## 6817 Greenwood

6817 Greenwood Ave N // Project# 3032404-LU  
Design Recommendation // Northwest Design Review Board  
Meeting Date // July 25th, 2022

6817 Greenwood Partners, LLC

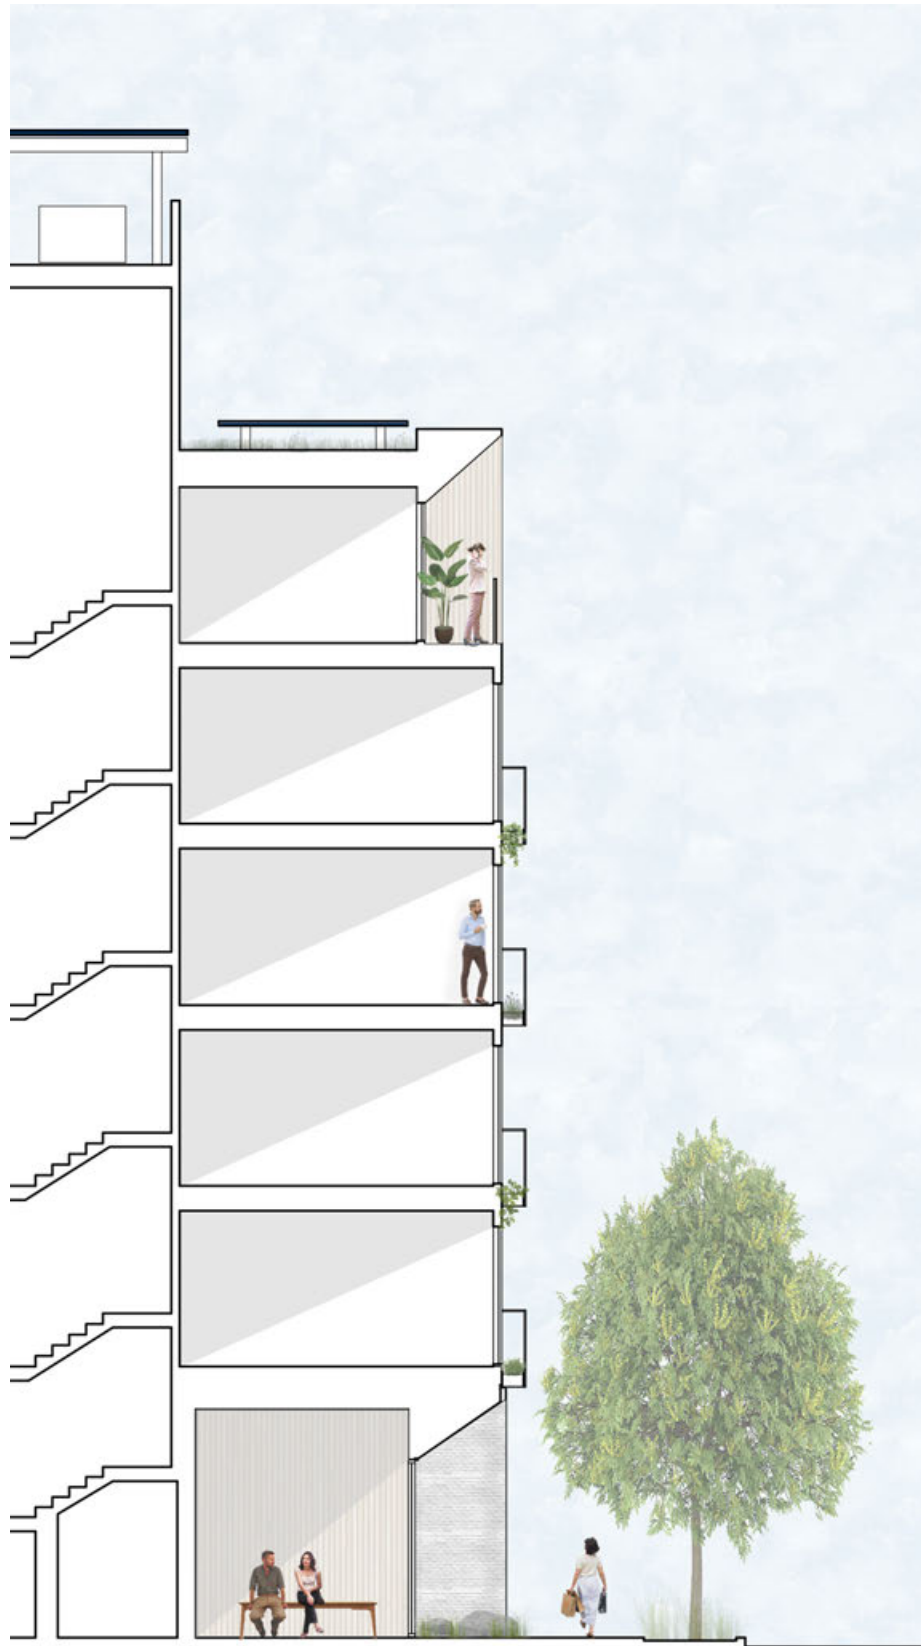
a. The Board directed further development of a hybrid massing option that combines the articulation and concept of the east façade of Option B with the setbacks of Option C. (CS2-A, CS2-D, CS3-A-3, CS3-A-4, CS3-I and CS3-II of the Greenwood-Phinney Neighborhood Design Guidelines)

b. The Board stated that Massing Option B's east façade is a more appropriate response to the character of the neighborhood. Its solid appearance and reduced glazing at the upper levels creates a street facing façade that better fits into the surrounding context of the Greenwood-Phinney neighborhood. (CS2-A, CS2-D, CS3-A-3, CS3-A-4, CS3-I and CS3-II of the Greenwood-Phinney Neighborhood Design Guidelines)

c. In agreement with public comment, the Board stated that the marriage of setbacks proposed in Massing Option C results in a more compatible structure to the adjacent church to the north and the surrounding context and character. Specifically, the Board would like to see the 5 foot setback from the north property line maintained. (CS2-A, CS2-D, CS3-A-3, CS3-A-4, CS3-I and CS3-II of the Greenwood-Phinney Neighborhood Design Guidelines)

d. The Board supported the bay concept on the east façade of Massing Option C as it is in keeping with the context of bays seen along Greenwood Avenue North. The Board encouraged maintaining the bay concept as the design evolves, but noted it is not crucial to the success of the design concept. (CS2-A, CS2-D, CS3-A-3, CS3-A-4, CS3-I and CS3-II of the Greenwood-Phinney Neighborhood Design Guidelines)

The project has adapted the massing and articulation concepts of Option B into a building with uniform setbacks along the north lot line seen in Option C.

The solid appearance of the building body is maintained. A lighter material is used at the ground floor and the penthouse level to help lighten the perceived massing of the building.

The 5 feet setback from the north property line has been maintained.

Through design studies that explored the synthesis of Options B and C, the bay concept has not been carried forward.

entry / southeast view

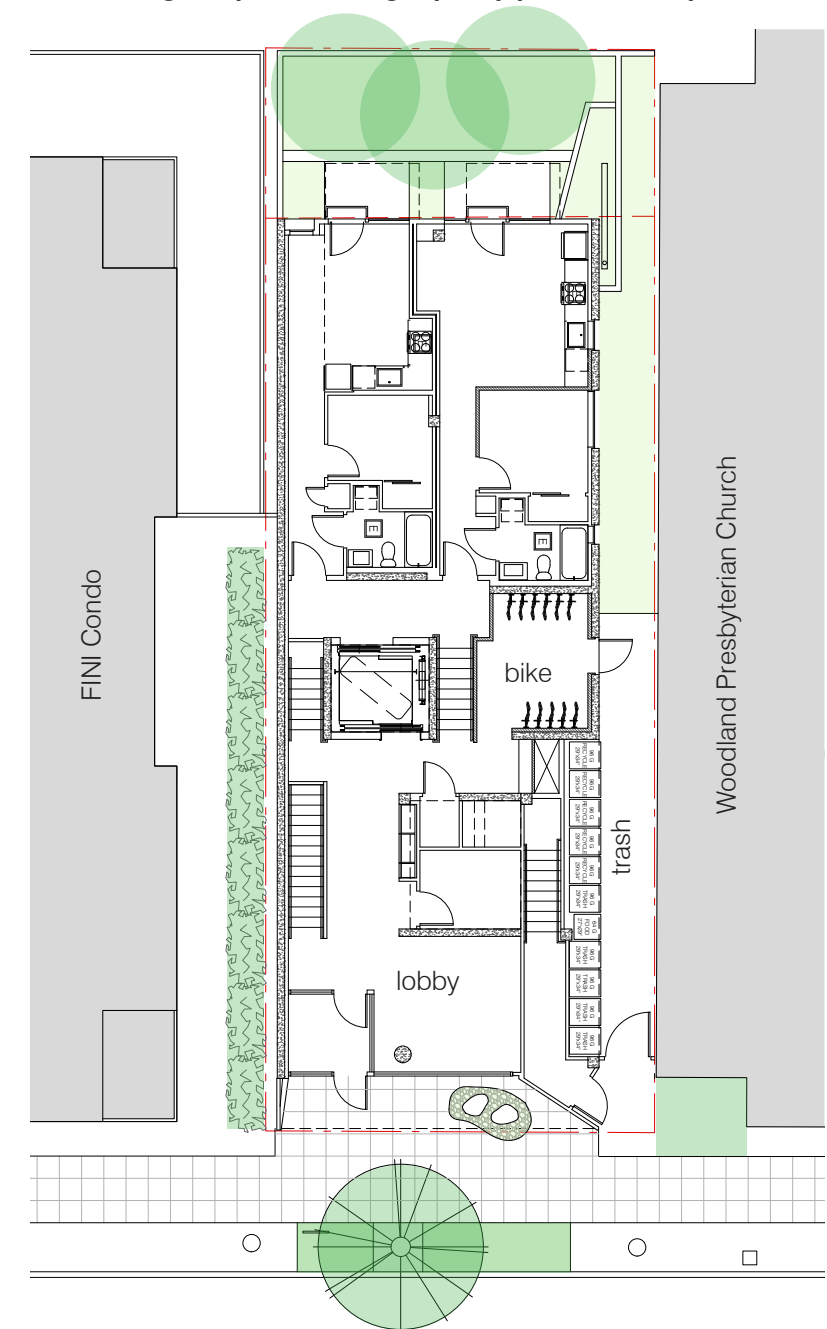
a. The Board noted it is not necessary to set the building back at the street level as it would be out of character with the architectural context and further constrain the narrow frontage. (CS2-A, CS2-B)

b. The Board supported the alternative ground level plan shown on page 49 of the EDG packet and noted that relocating the solid waste storage room and exit to the north façade reduces the blank wall condition along the street frontage. The Board requested a high level of glazing and transparency along the street. Additionally, if the location of the penthouse, elevator, and stair core is contributing to the blank wall condition, it would be acceptable for it to be moved to the south property line. (PL3-A, PL3-C, DC2-B-2)

c. The Board deliberated on the requested departure from blank façade requirements, as discussed in the departure section of the report below. If the request is maintained and a portion of east façade is blank at the ground level, the Board requested further study of treatment options that provide texture and engagement. (PL3-A, PL3-C, DC2-B-2)

*d. In response to public comment, the Board noted the importance of providing a high-quality pedestrian experience through transparency and materiality. (PL1-B- 3, PL2-B-3, PL3-C, DC4-A-1, DC4-II-I of the Greenwood-Phinney Neighborhood Design Guidelines)*

The ground level is no longer setback across the frontage. Instead, it is inflected inward to create a recessed entry space similar to other projects along Greenwood. The canted brick creates a dynamic entry space that simultaneously maintains the street edge, expands the public realm, and provides shelter to the entry.

Trash has been located on the northern edge of the building, away from the street entry. Trash will be stored in 96 gallon totes that will be retrieved from the storage area on collection day. There will be no staging of trash containers on the sidewalk. Glazing has been added to the street level; the project satisfies the blank façade requirement.

The blank wall has been reduced from 16'-3" to 8'-2".

The transparency at street level has been increased from 45% to 72% to greatly strengthen the connections between the project and the pedestrian experience. Brick, high quality paving, a solid wood door, and seating will provide a high quality pedestrian experience.

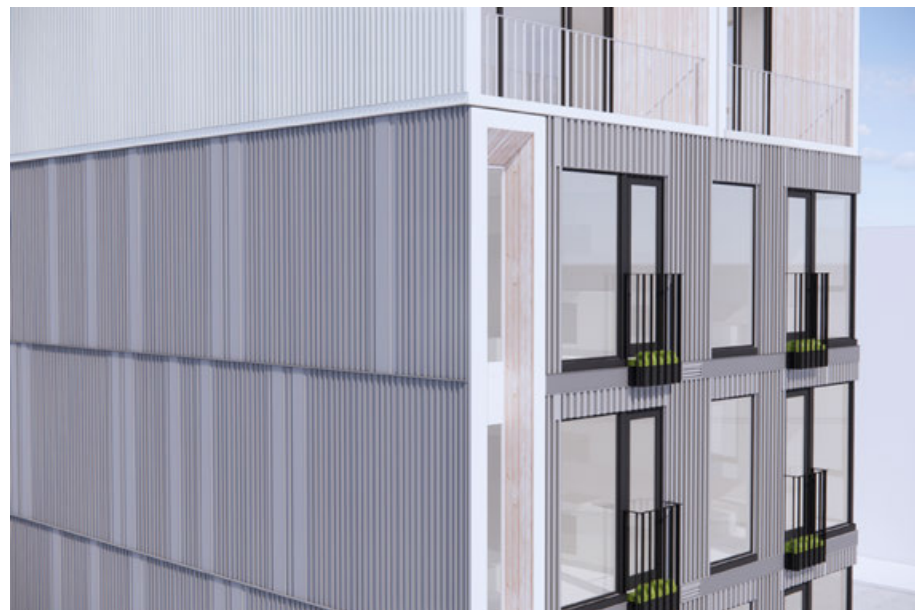
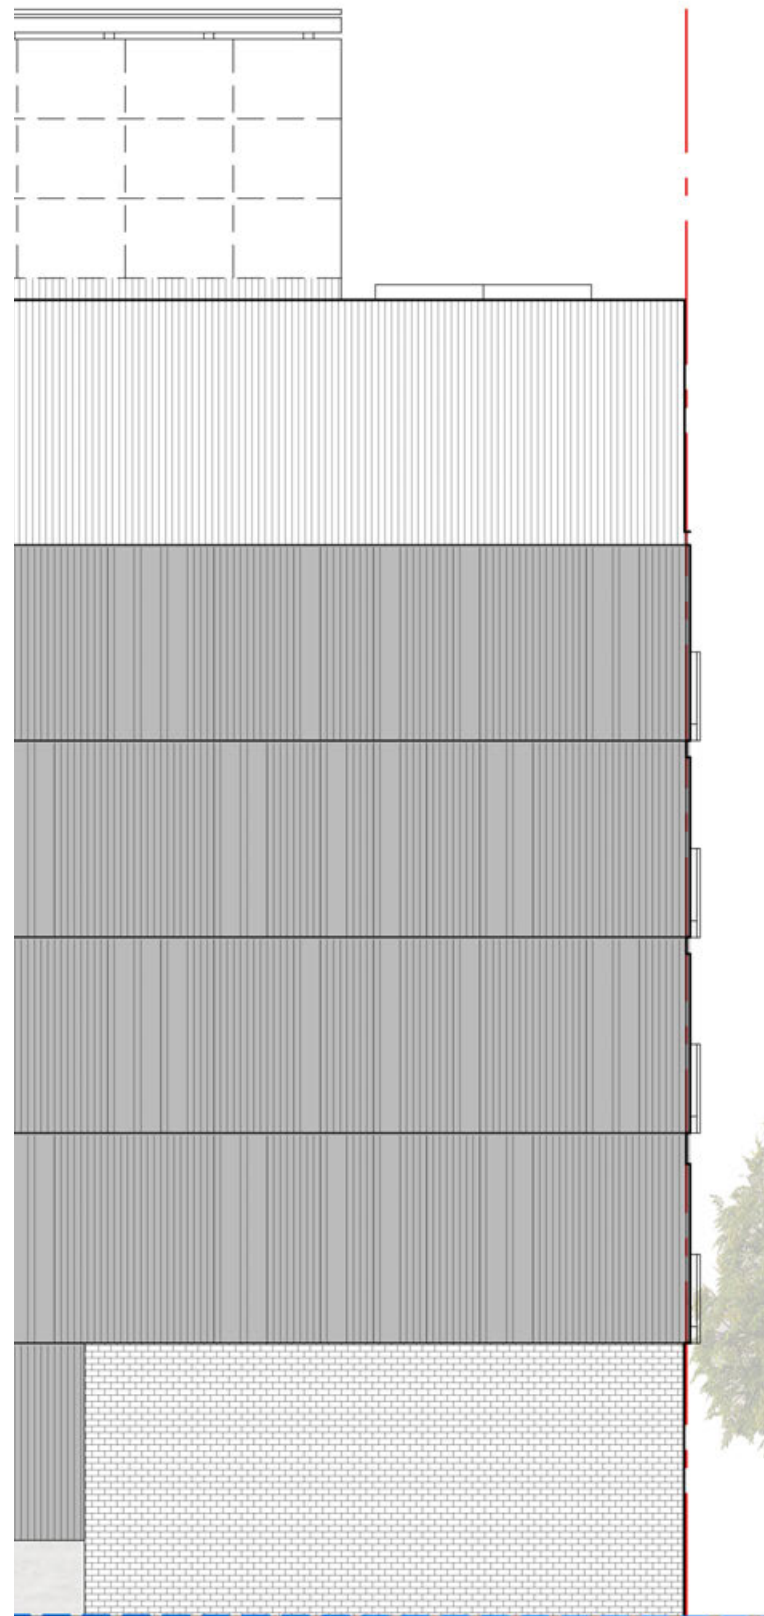
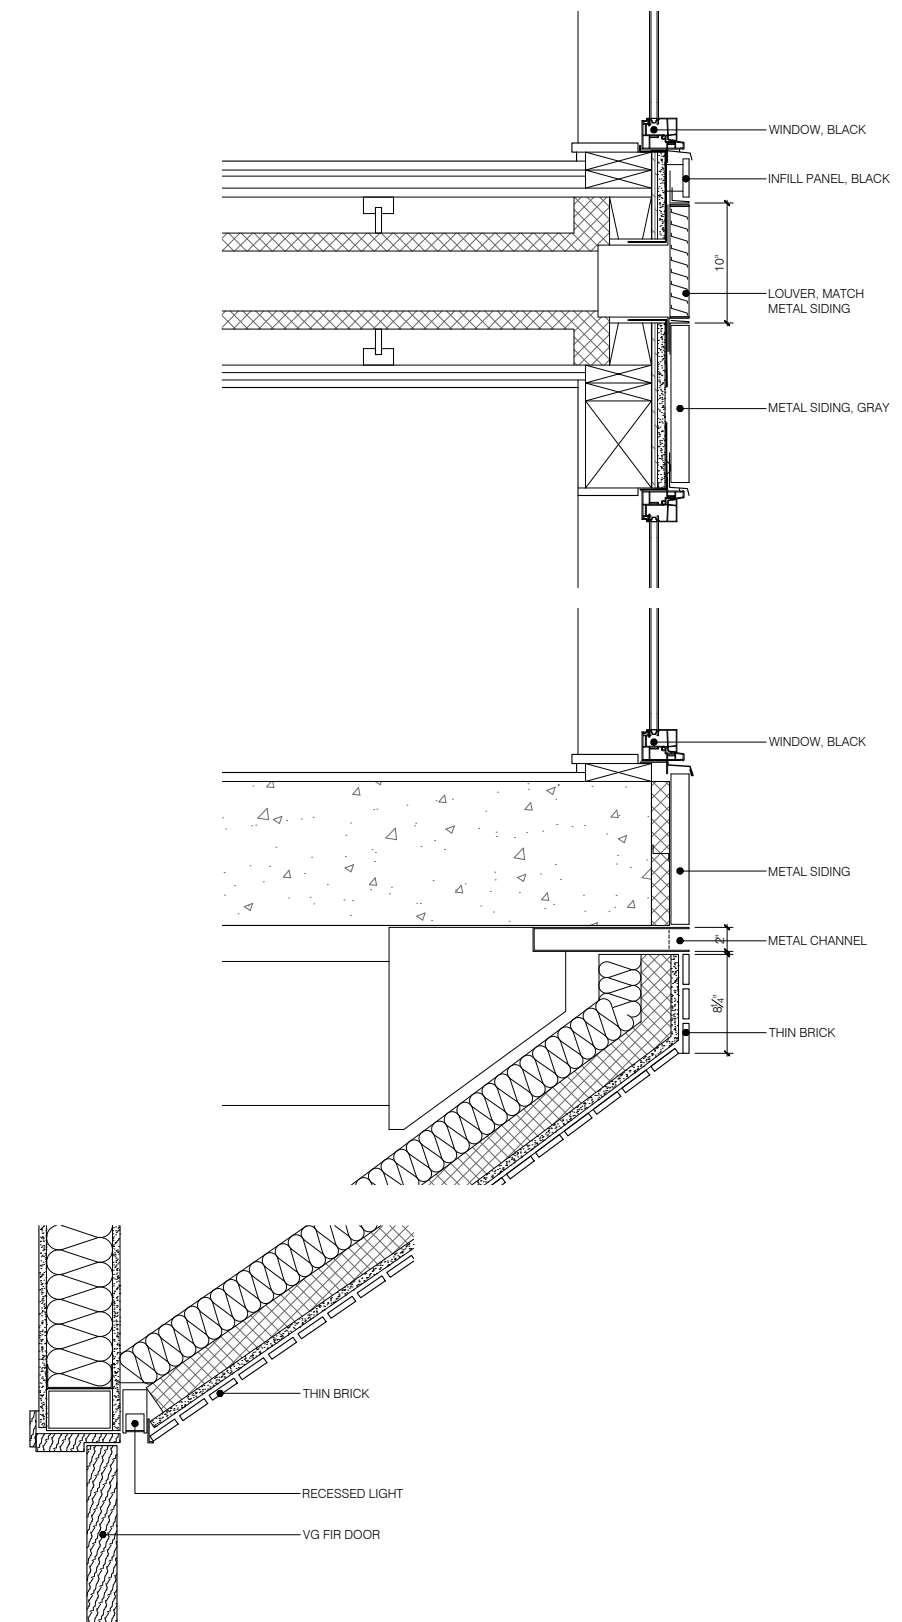
a. The Board supported the composition and backdrop tapestry concept of the north and south facades of Massing Options B and C. The Board noted that the semi-random pattern of window openings and panel widths complement the overall design concept and the building's context within the neighborhood. The Board recommended maintaining these facade expressions as the design evolves. (CS2-A, DC2-B-1)

The north and south facades have maintained articulation at the floor lines and utilize material texture variation to maintain the façade expressions shown in the EDG presentation.

building section / west

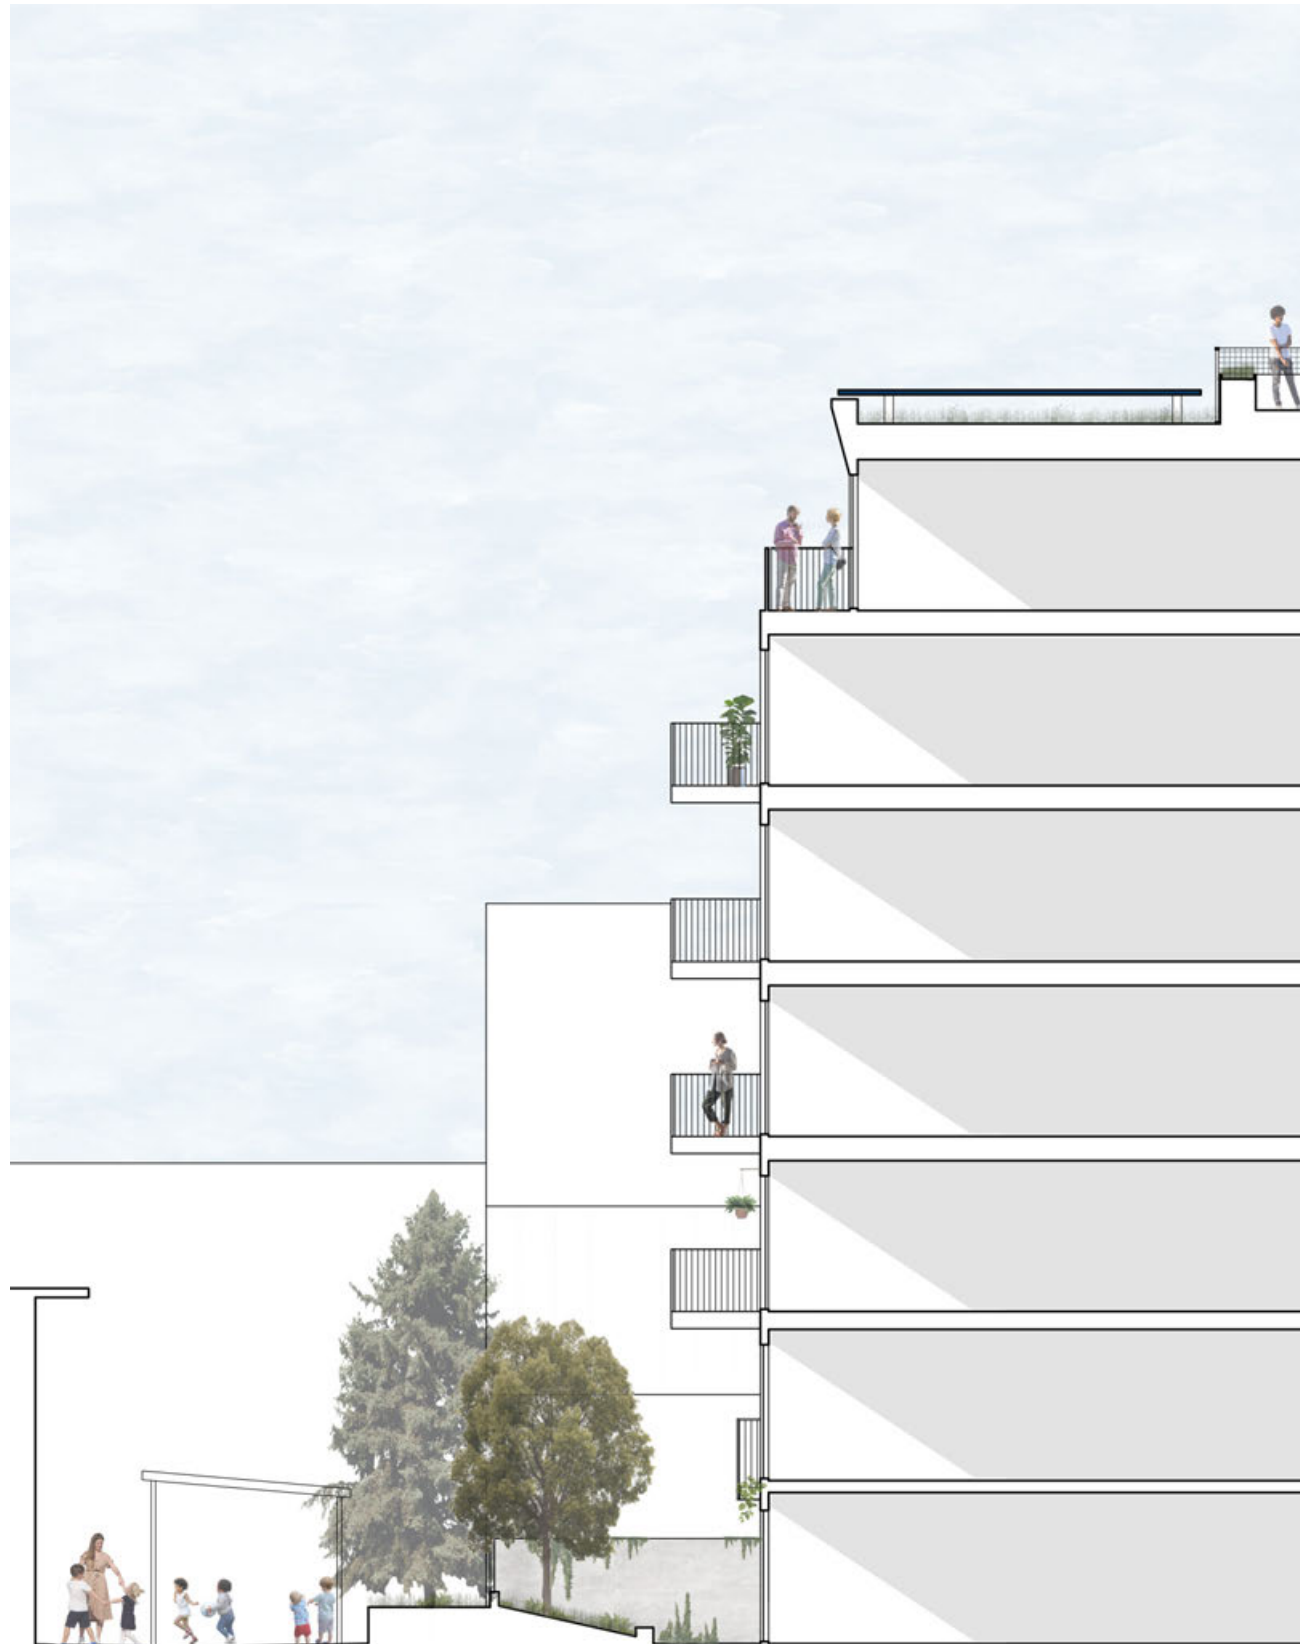
*a. The Board supported the light and open quality of the balconies on the west façade of Massing Option C as they appear to be floating and better assist in the transition to the single-family zone to the west. (DC2, DC2-C)*

*b. The Board preferred the balcony configuration of Massing Option C; however, they acknowledged that evolution of the mass in response to guidance may affect the design resolution of the west façade. (DC2, DC2-C)*

**The light and open quality of the balconies on the west facades has been maintained.**

**The balcony configuration of Massing Option C has been maintained on floors one through five. The sixth floor level has been stepped back and utilizes the same materials and articulation of the street facade to create consistent and integrated architectural language on all facades.**
